**Re: Request for Appeal and Agenda Placement, October 15, 2025 Planning Board Meeting**

Eastern Development, LLC respectfully requests that this appeal be placed on the Planning Board's October 2025 agenda. The appeal seeks modification of conditions imposed on the final approval of the above-referenced project relating to:

# Granite Ridge Estates Cluster Subdivision

NOT TO SCALE

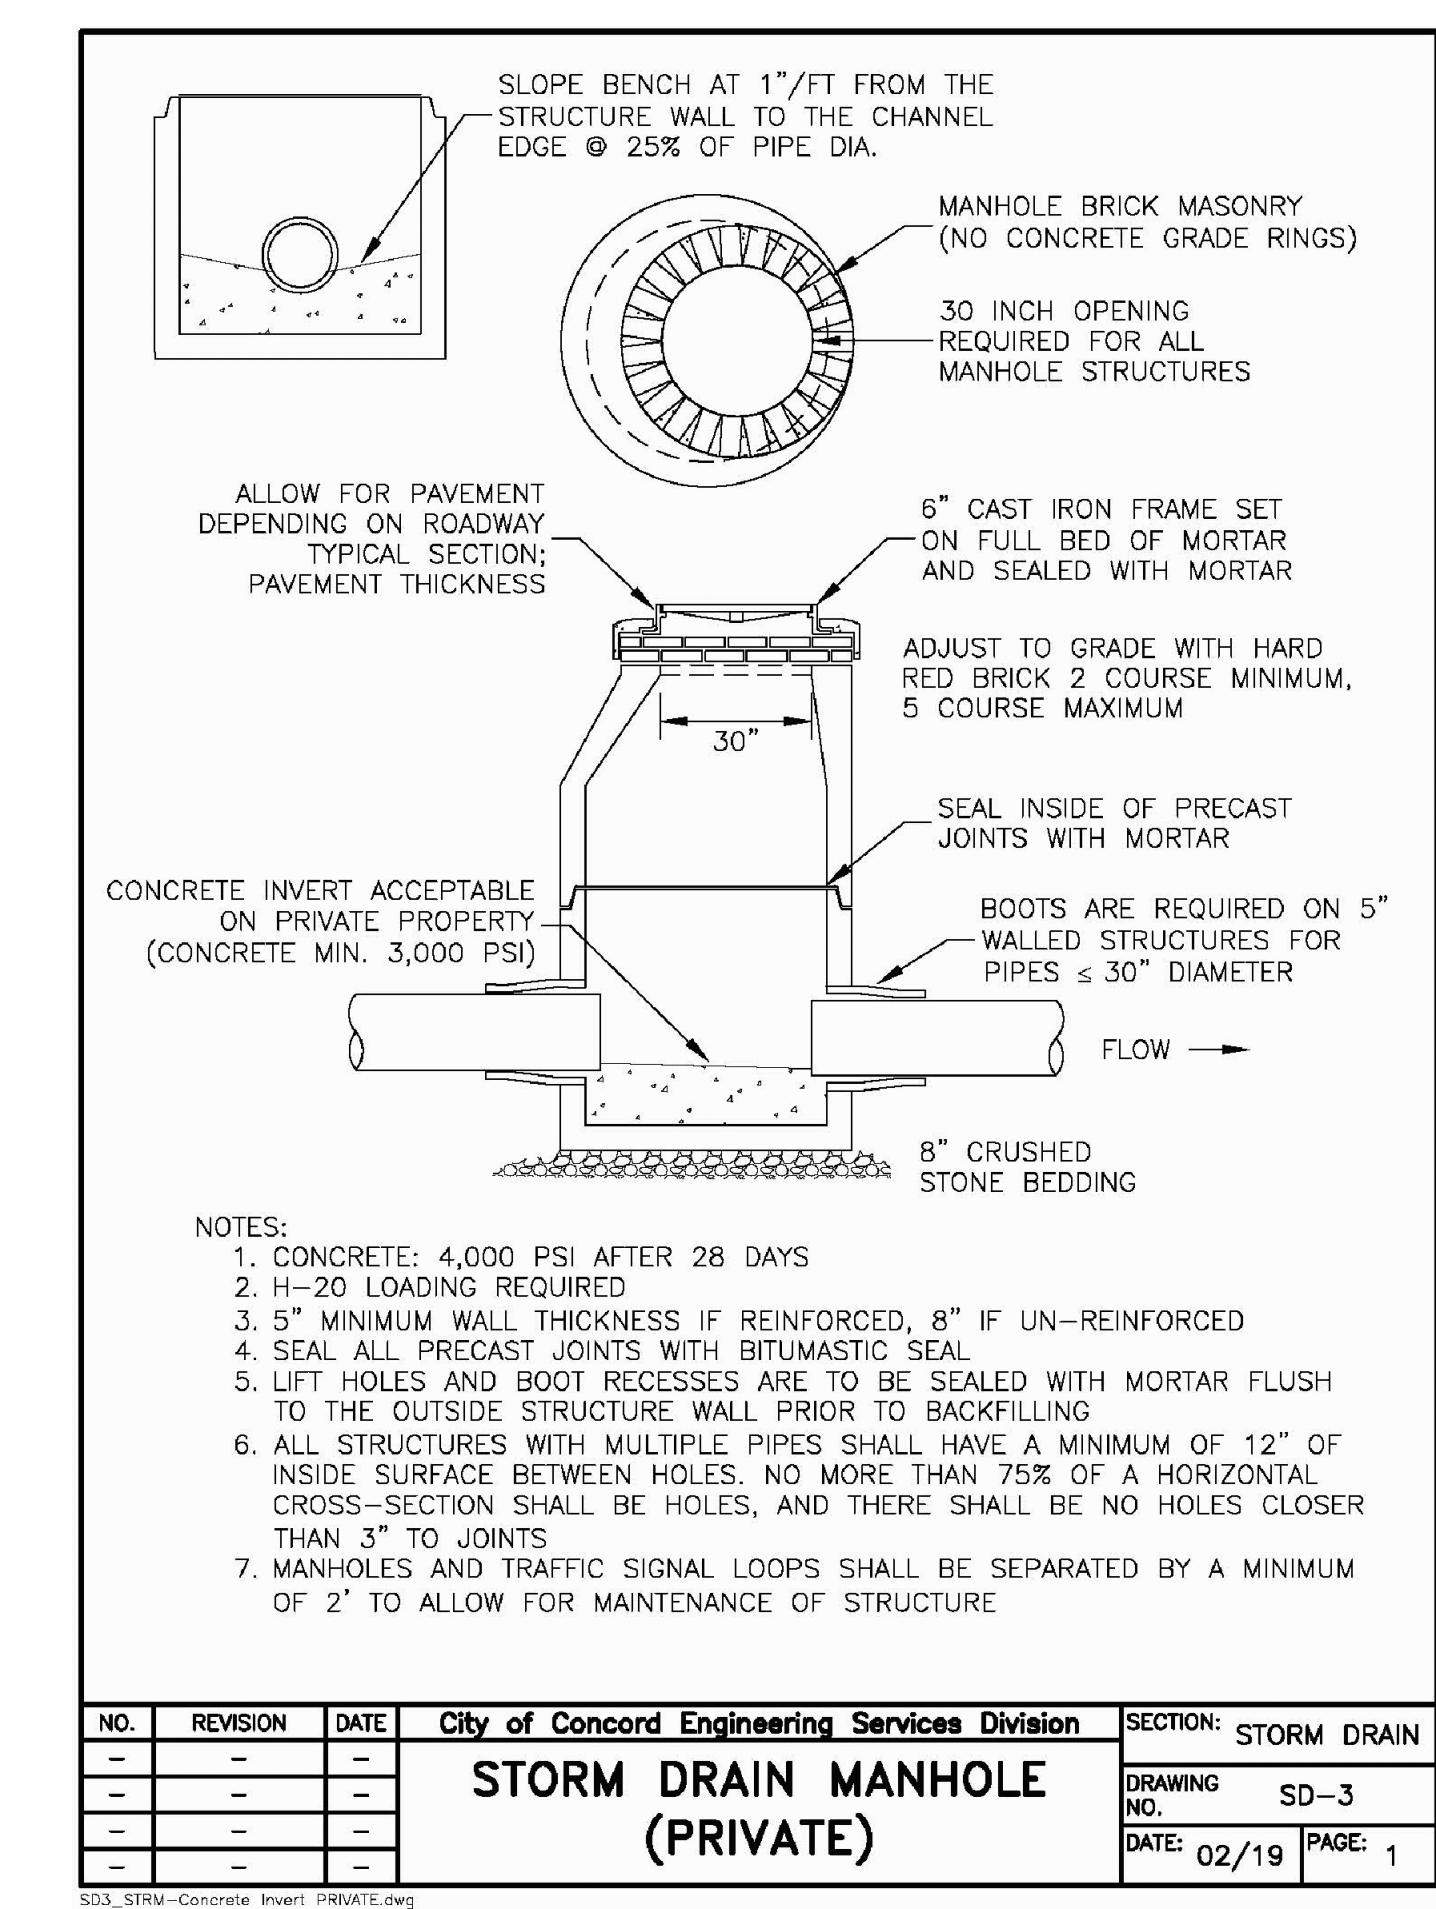
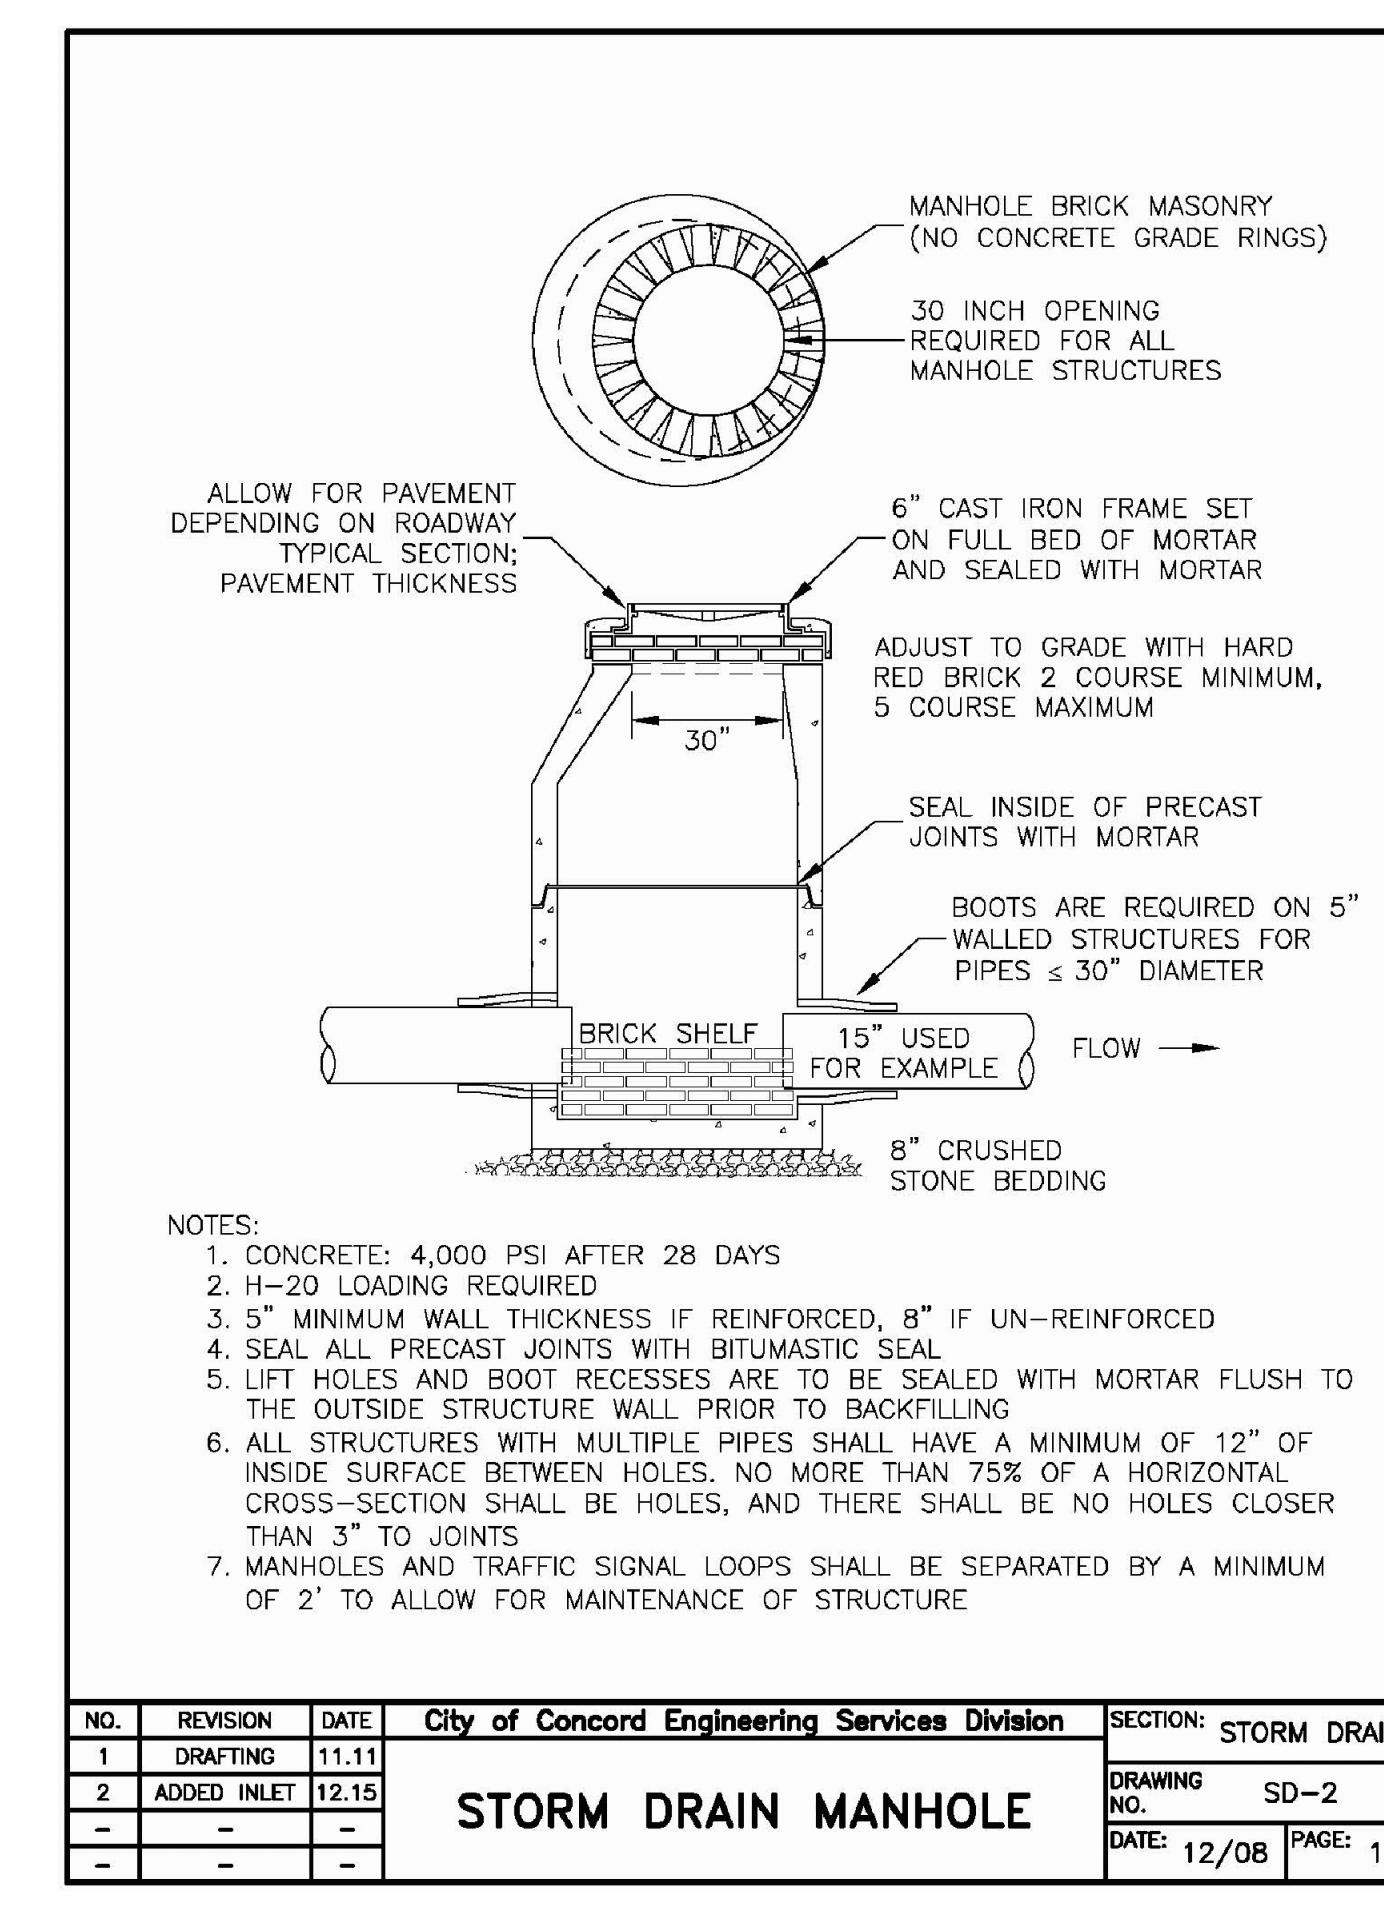
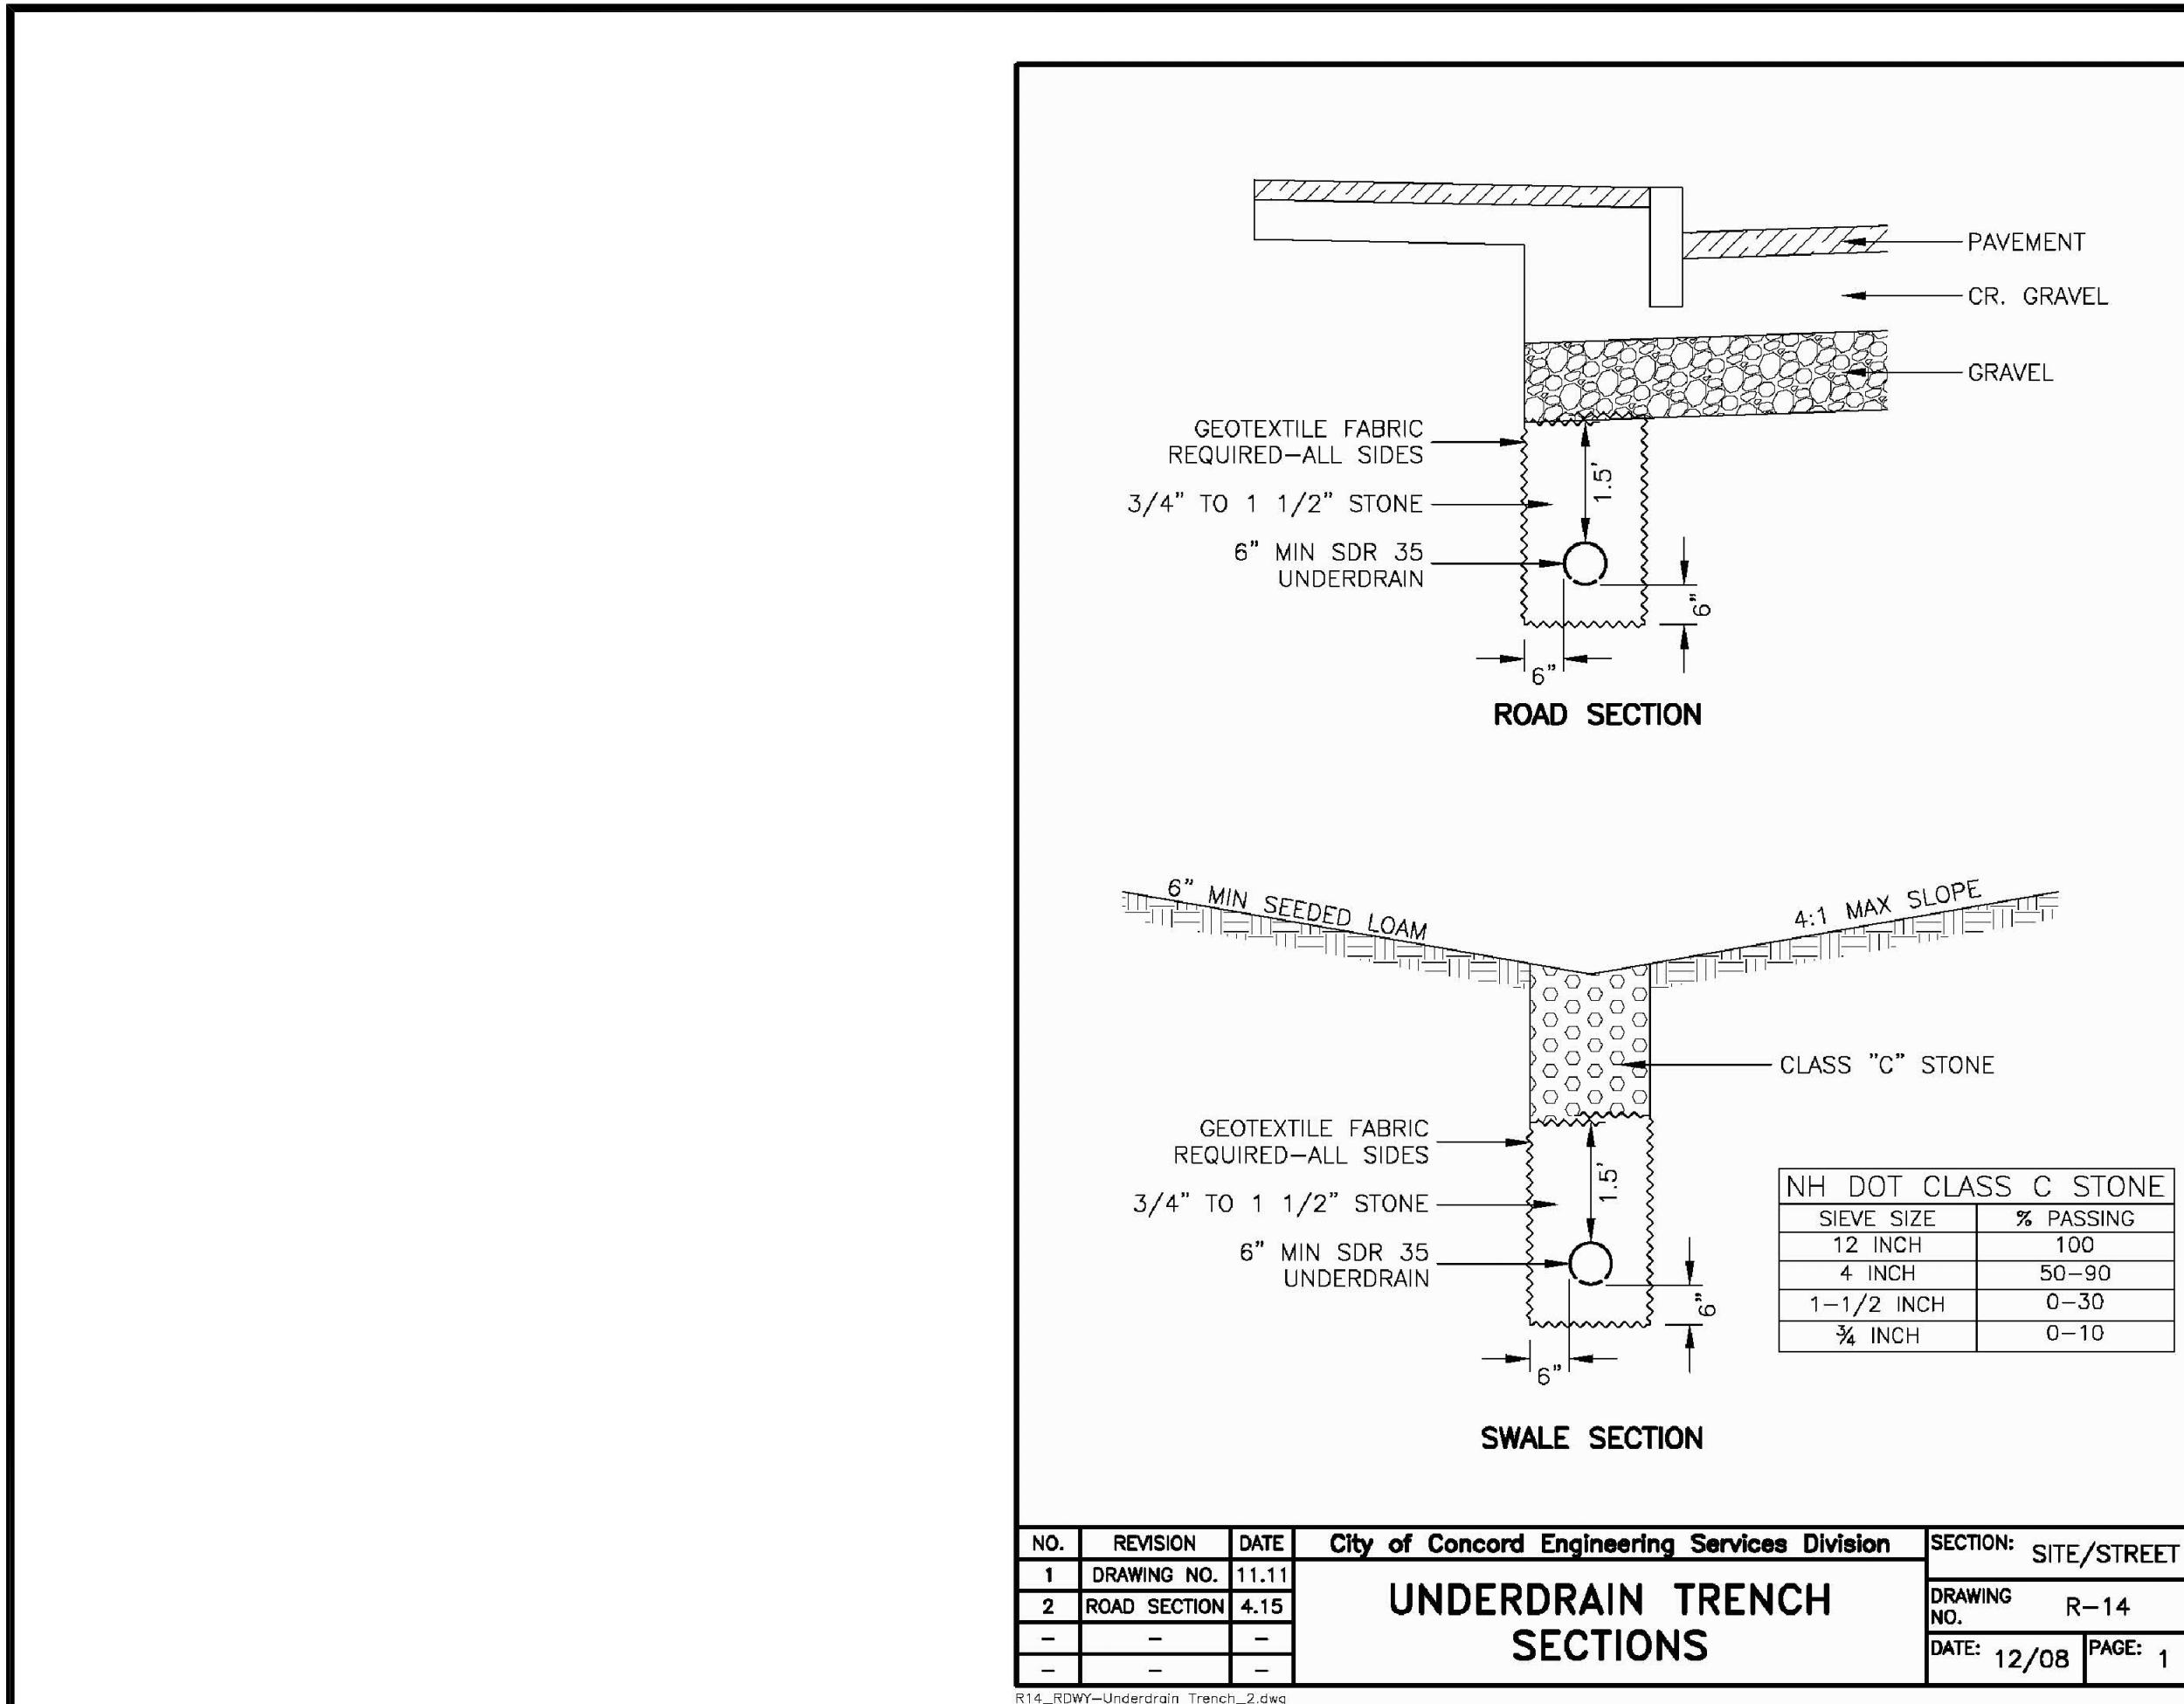
## 4. Pavement Thickness: Code, Standards, and Engineering Basis

Concord’s Subdivision Regulations 21.05 state: “*Common private drives shall be surfaced with a minimum of three (3) inches of hot bituminous pavement per State specifications.*” The project

proposes exactly that standard, 1.5" binder and 1.5" wearing course, compacted to 3 inches total, consistent with NHDOT Section 401 Plant-Mixed Pavements, which Concord expressly references. The city's 2020 Construction Standards & Details also specify for driveways a section of 6" crushed gravel plus 3" hot bituminous pavement in two lifts, aligning with 21.05's minimum requirement for common private drives.

At the May 15, 2024, meeting, the city objected to the 3" pavement thickness but did not present factual evidence or engineering data. The minutes reflect:

- An acknowledged inconsistency between the Subdivision Regulations (3") and a Construction Standards detail (4").
- The city Engineer's statement that 3" is the state minimum standard for rural residential roads and sufficient for low-volume facilities.
- Staff noted they intended to "fix" the verbiage to require 4" in the future, but no such amendment had been adopted.
- Several Board members recognized that 3" was acceptable and that any inconsistency would not affect the city, since the roadway is private and HOA-maintained.

Neither Concord nor NHDOT has produced findings that 4" performs materially better than 3" for private, low-volume roads. Absent unusual conditions (heavy truck use, poor soils, drainage issues), there is no engineering or legal justification for exceeding the codified 3" minimum.

**Requested Action:** Approve the project's 3" compacted HBP pavement section as compliant with:

- Concord Subdivision Regulations 21.05 (minimum 3" requirement),
- NHDOT Section 401 (state standard).
